Sewerage Impact Assessment Report
with Response-to-Comment

Section 12A Rezoning Application for Proposed Columbarium on Various Lots in D.D.41, Sha Tau Kok, New Territories

Sewerage Impact Assessment Report

Reference: P036/03 Issue 3

Figure 2.1	Site Location and Its Environs
Figure 3.1	Existing and Proposed Sewerage System
Figure 3.1a	Sewers U1 – U5
Figure 3.1b	Sewers A1 – A10
Figure 3.1c	Sewers A11 – A16
Figure 3.1d	Sewers A17 – A23
Figure 3.1e	Sewers A24 – P3

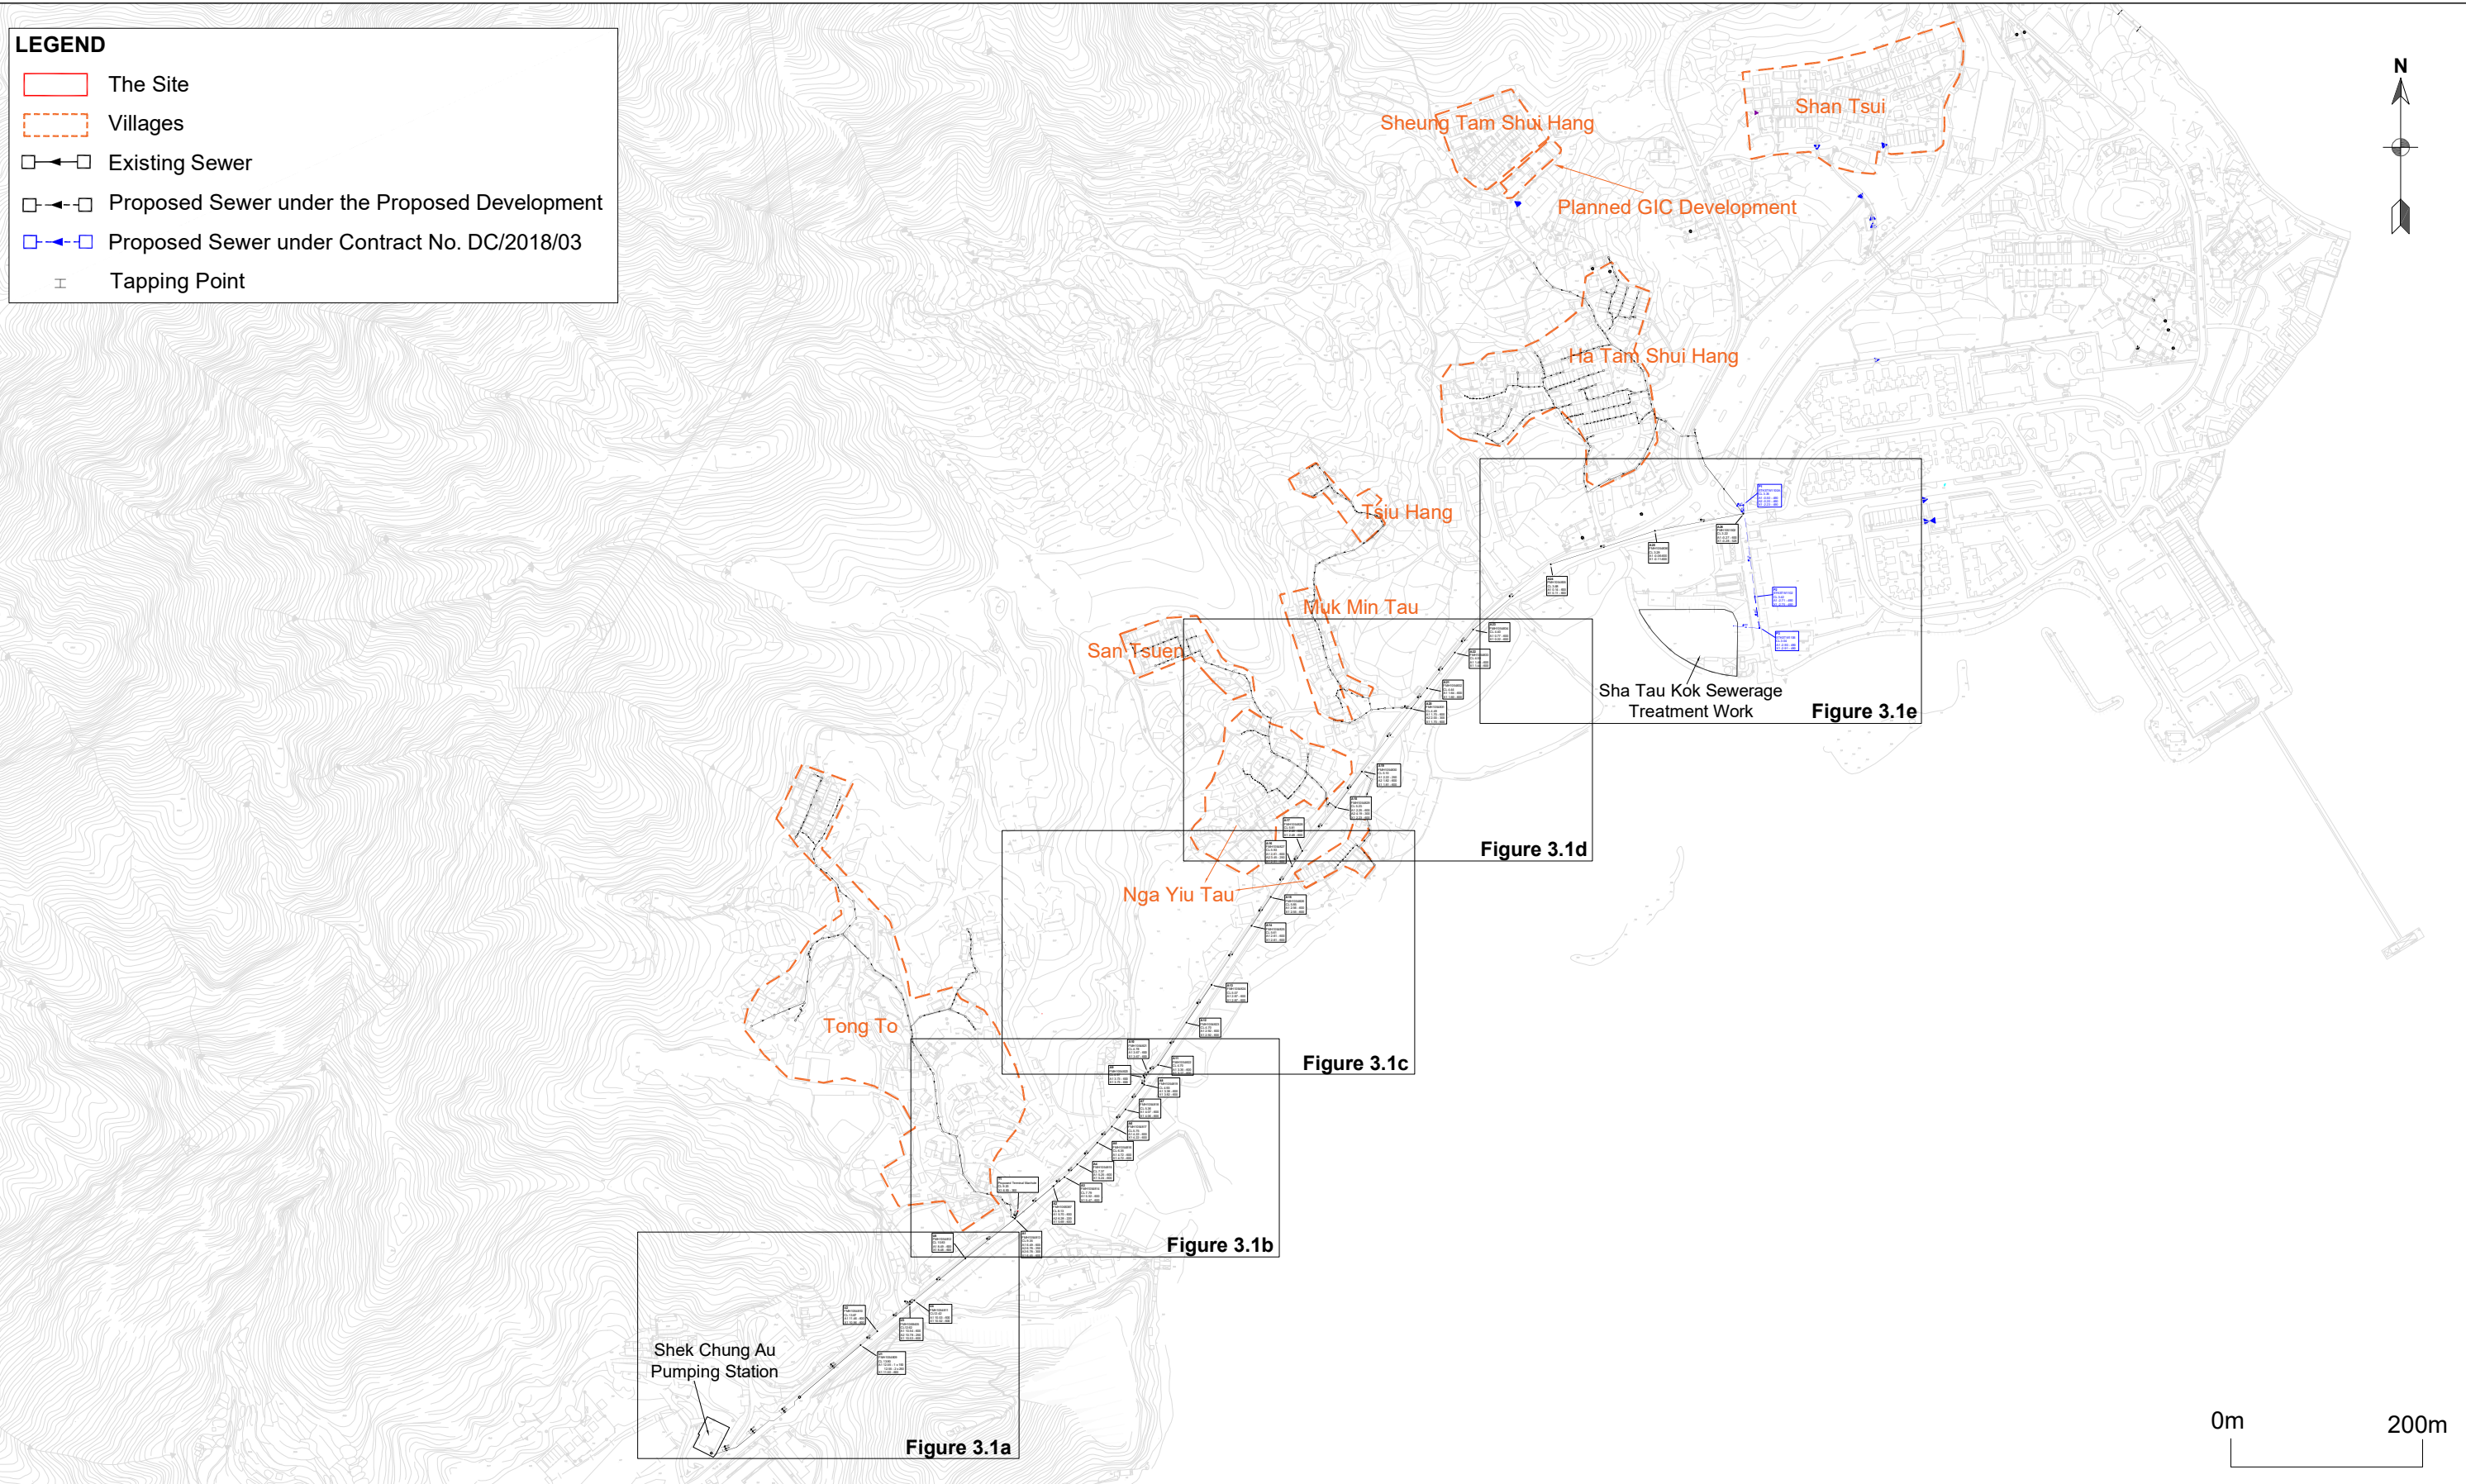
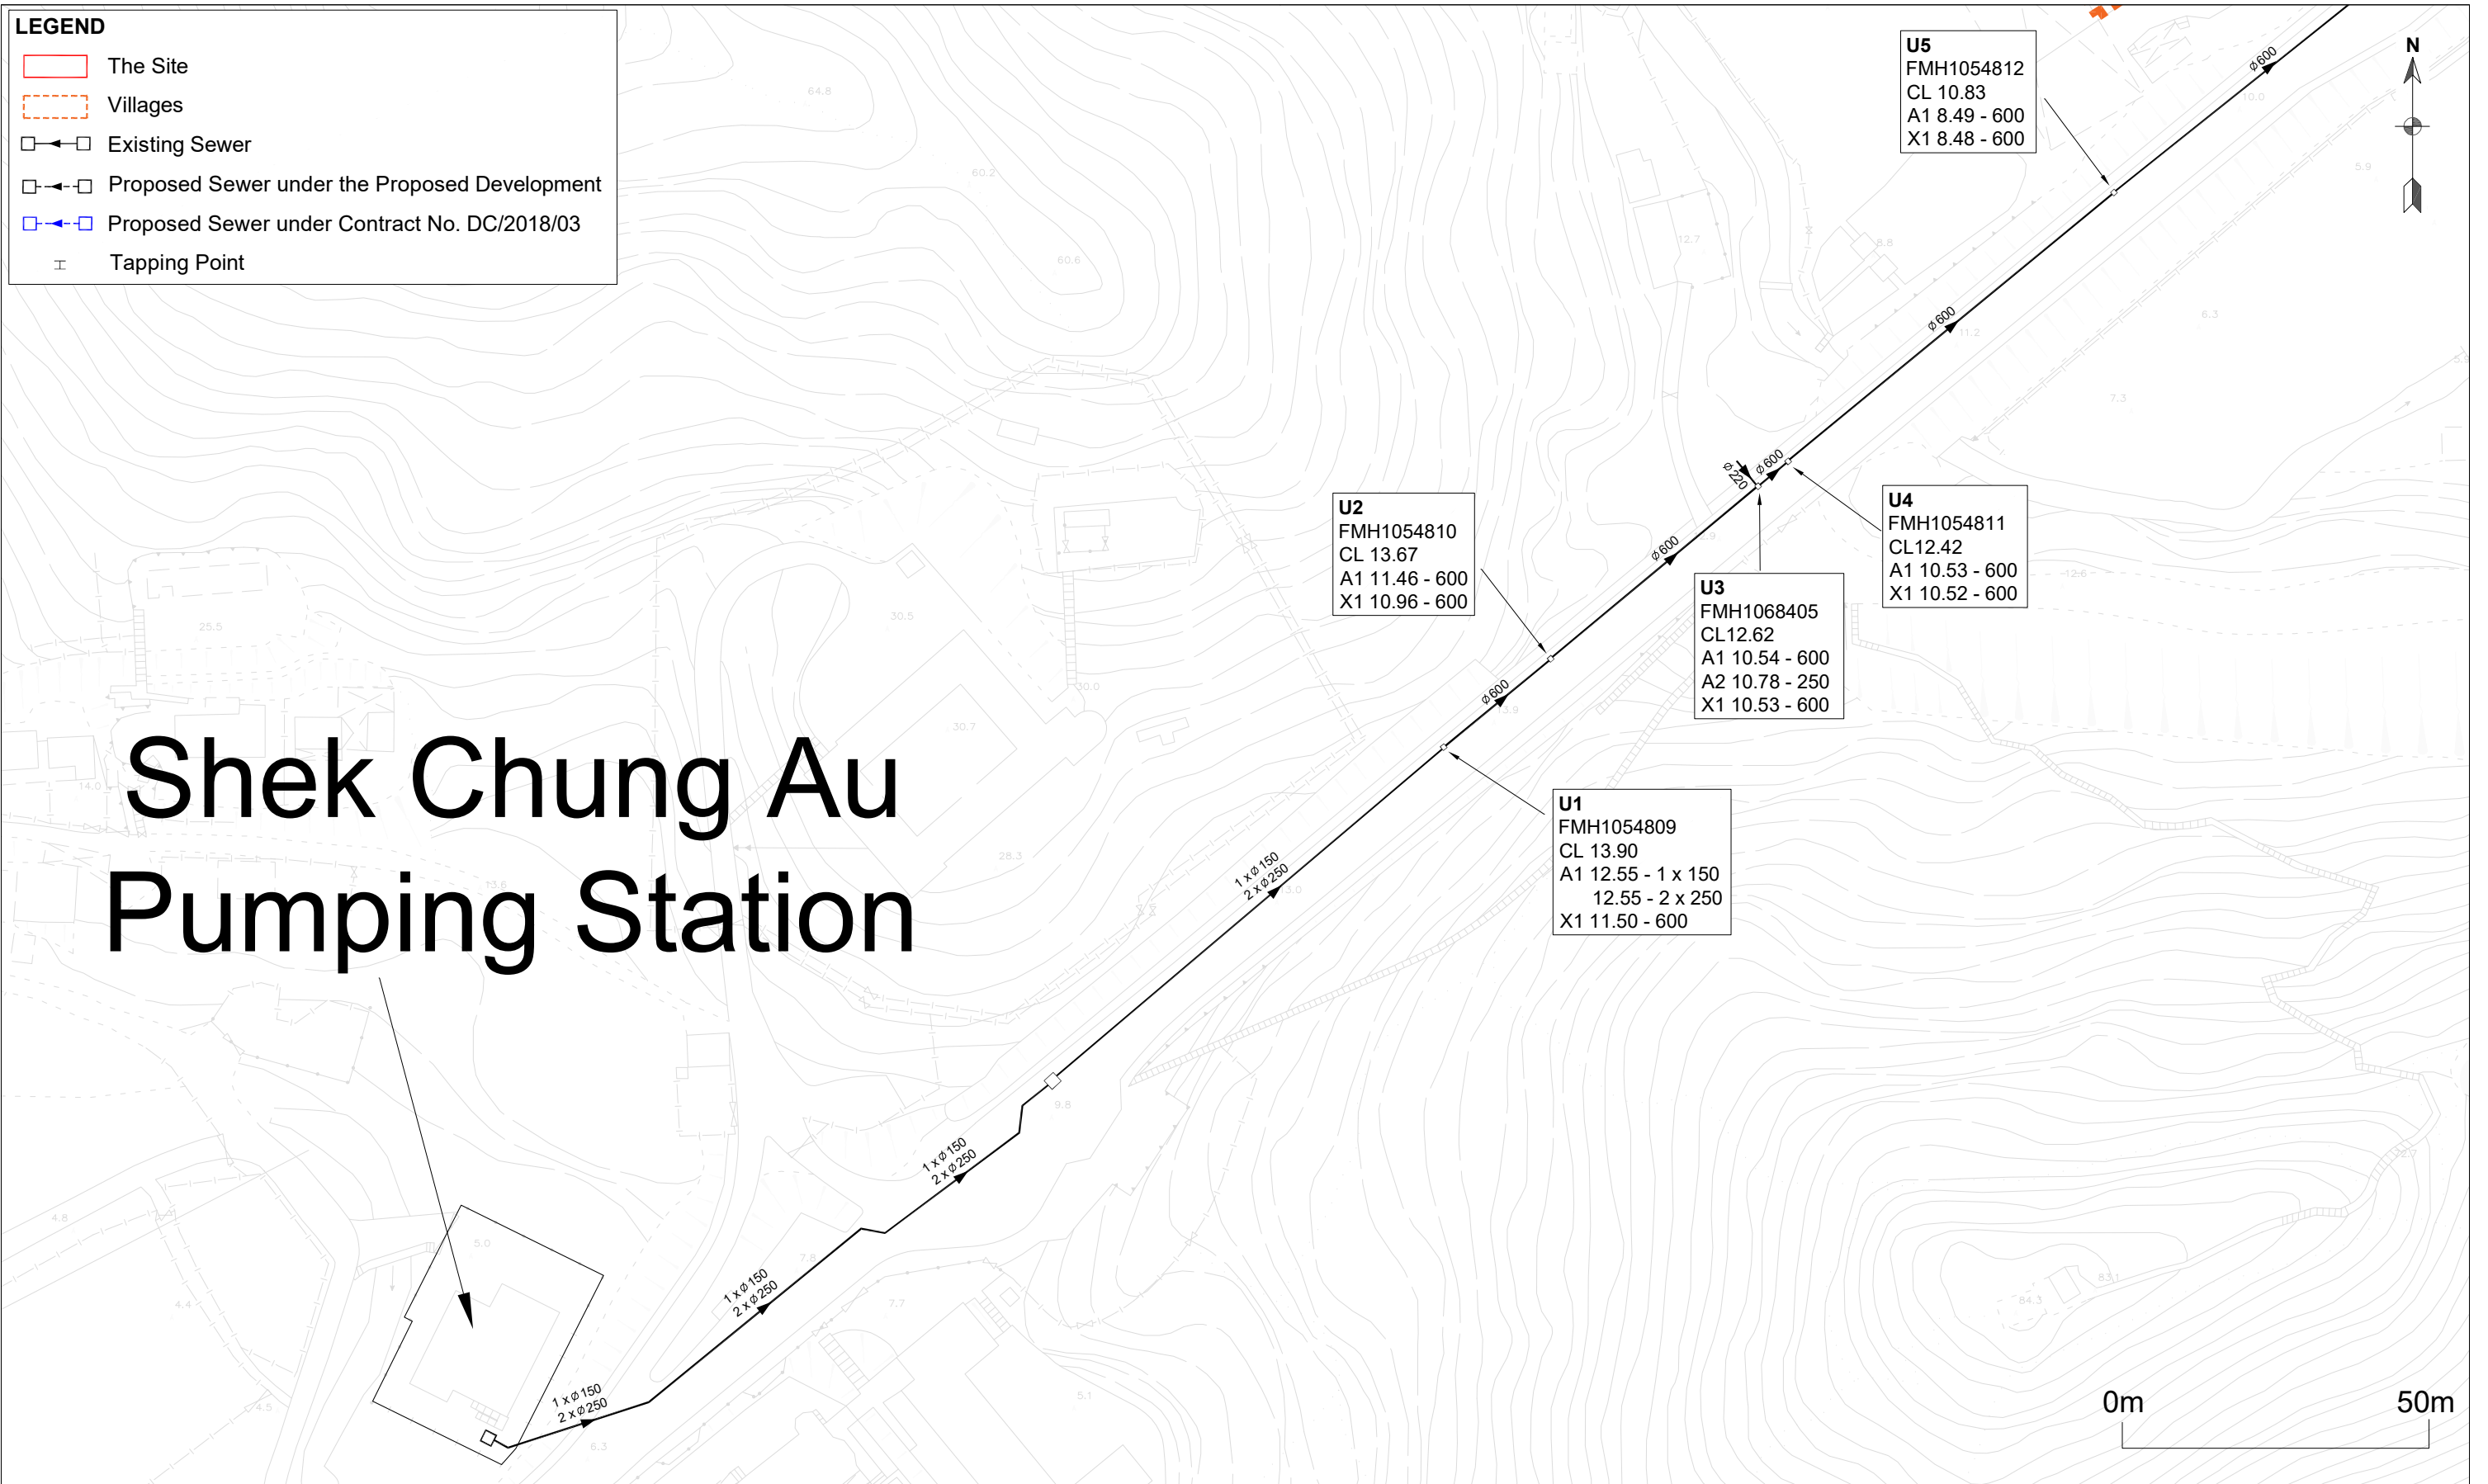
Items	Comments	Response
Comments on Sewerage Impact Assessment from DSD		
a	This SIA report needs to meet the satisfaction of EPD, the planning authority of sewerage infrastructure.	Noted.
b	The applicant should check and ensure that the existing sewerage system to which the proposed connection will be made have adequate capacity and satisfactory condition to cater for the additional discharge from the site. He should also ensure that the flow from this site will not overload the existing sewerage system.	Noted.
c	Figure 3.1 should show the alignment of all existing public sewerage network in the vicinity of the site. The applicant should ensure that a 3m clear distance between the proposed structure and the existing public sewerage network would be maintained.	Noted. Figure 3.1 shows the alignment of existing public sewerage networks along Sha Tau Kok – Shek Chung Au. It is confirmed that a distance of more than 3m between the proposed structure and the existing public sewerage network is maintained. Please refer to Figure 3.1.

d	Consideration should be given to adopt polyethylene (PE100) pipe for buried sewage pipe beyond the sewage terminal manhole.	Noted. Polyethylene (PE100) pipe will be adopted.
e	The location of the terminal manhole shall be designed and constructed close to the lot boundary as far as practicable.	Noted and revised. The location of the terminal manhole has been designed to be as close to the lot boundary as possible. Please refer to Figure 3.1.

Comments on Sewerage Impact Assessment from DSD		
1	Figure 3.1 has not shown the alignment of all existing public sewerage network in the vicinity of the site (e.g. the sewerage system at Tong To). The applicant should review.	Noted and updated. Please refer to Figure 3.1.
2	RtoC item h: Please update section 5 regarding the handover arrangement of sewerage pipe to DSD. Please note that DSD would only consider taking up the maintenance of connection pipe located downstream of the terminal manhole and outside the private lot boundaries after satisfactory technical audit by DSD. The applicant should be responsible for the maintenance of pipes constructed under this development which have not been handed-over to other parties for maintenance.	Noted and revised. Please refer to Section 5.
3	Unless the applicant can submit satisfactory DIA and SIA reports, I do not support the application.	Noted.
